APPLICATION NO. FILING DATE		FIRST NAMED INVENTOR	ATTORNEY DOCKET NO.	CONFIRMATION NO.	
10/719,352	11/21/2003	John R. Wall	3257-031853 3304		
28289	7590 07/18/2005		EXAMINER		
	B LAW FIRM, P.C.	MILLS, DANIEL J			
	RS BUILDING TH AVENUE	ART UNIT	PAPER NUMBER		
PITTSBURG	GH, PA 15219	3679			
			DATE MAILED: 07/18/2005

Application	No.	Applicant(s)				
Office Action Summary		10/719,352		WALL, JOHN R.				
		Examiner		Art Unit				
		Daniel J. Mil	ls	3679				
The MAILING DATE of this communication appears on the cover sheet with the correspondence address Period for Reply								
A SHORTENED STATUTORY PERIOD FOR REPLY IS SET TO EXPIRE 3 MONTH(S) FROM THE MAILING DATE OF THIS COMMUNICATION. - Extensions of time may be available under the provisions of 37 CFR 1.136(a). In no event, however, may a reply be timely filed after SIX (6) MONTHS from the mailing date of this communication. - If the period for reply specified above is less than thirty (30) days, a reply within the statutory minimum of thirty (30) days will be considered timely. - If NO period for reply is specified above, the maximum statutory period will apply and will expire SIX (6) MONTHS from the mailing date of this communica

Figure 1

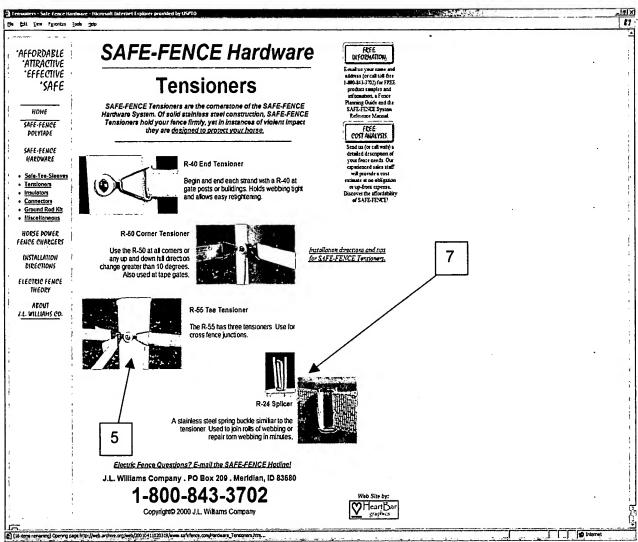
As to claim 1, Safe-Fence discloses a fence comprising a rail consisting of at least two metal wires ensheathed in a plastic web (the webbing used for the fence is disclosed as having stainless steel wires interwoven), a slotted connector (1) having a face plate (encompases the entirety of 1) with two slots (A and B) and a middle portion (3) separating the two slots, the connector having a front side (facing away from reader)

and a rear side (facing toward reader) and also having a post attachment end (2), a free end of the rail (4) being disposed in the slotted connector so that the rail runs from the front side of the connector through a first slot (A) nearest the post attachment end, round the middle portion (3), and then back through the second slot (B), and a post (5) to which the end connector is attached using a fastener (5).

As to claim 2, Safe-Fence discloses a fence wherein the end connector comprises return edges extending along opposing sides of the rigid member, the return edges extending perpendicularly from the faceplate (the hooks 6 shown on either side of component 2 on the R-50 corner tensioner, curve perpedicularly away from the plane of the faceplate).

As to claim 3, Safe-Fence discloses a fence wherein the end connector is attached to the post using a fastener (see figure 1) which permits the connector to pivot about the fastener.

As to claim 6, Safe-Fence discloses a fence wherein the faceplate (encompases the entirety of 1 includes a bend between the first slot and the post attachment end (2) (this is shown in figure 1 in the photo of the R-50 corner tensioner).

Figure 2

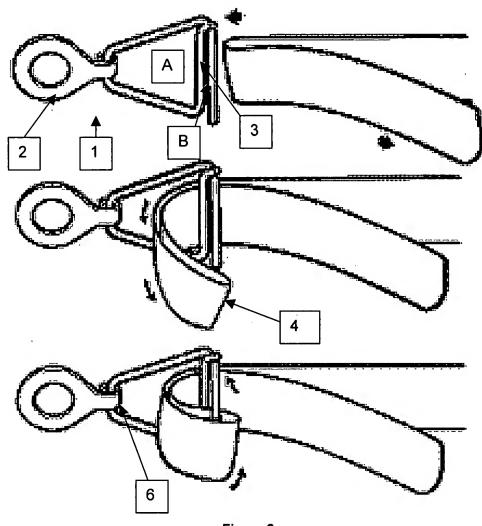
As to claim 10, Safe-Fence discloses a fence further including a slotted joining connector (7) having a face plate with a first slot (8), a second slot (9), and a third slot (10), the joining connector having a front side (into the paper) and a rear side (out of the paper).

As to claim 12, Safe-Fence discloses a fence wherein the first slot (8) and the second slot (9) are adapted to receive the abutting end of the first rail (11) and the second slot (9) and the third slot (10) are adapted to receive the abutting end of the second rail (12).

As to claim 14, Safe-Fence discloses a connector (7) including three slots (8, 9, 10) each being parallel to and spaced from its adjacent slot, with the middle slot being slightly wider than the two end slots.
